Product Change Notice (PCN)

PCN Number: **PCN-0451204R-01**

Product(s) Affected: **PJ-057AH**

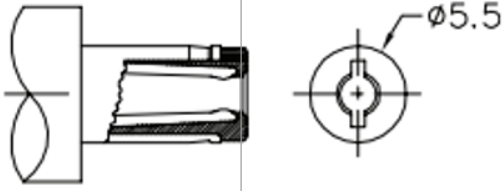
Description of Change: **Minor Housing and footprint differences. Material Change on the housing and terminals. See image Below**

PREVIOUS CUI DEVICE'S DETAIL / IMAGE			NEW CUI DEVICE'S DETAIL / IMAGE		
	MATERIAL	PLATING	DESCRIPTION	MATERIAL	PLATING/COLOR
center pin	copper	nickel	center pin	brass	nickel
terminal 1	brass	silver	terminal 1	brass t=0.40	silver
terminal 2	copper alloy	silver	terminal 2	bronze t=0.30	silver
terminal 3	brass	silver	terminal 3	brass t=0.40	silver
plastic	PBT		cover	PA10T (UL94V-0)	black
			housing	PA10T (UL94V-0)	black

MATING PLUG
Jack Insertion Depth: 9.15 mm

MATING PLUG
Jack Insertion Depth: 9.45 mm
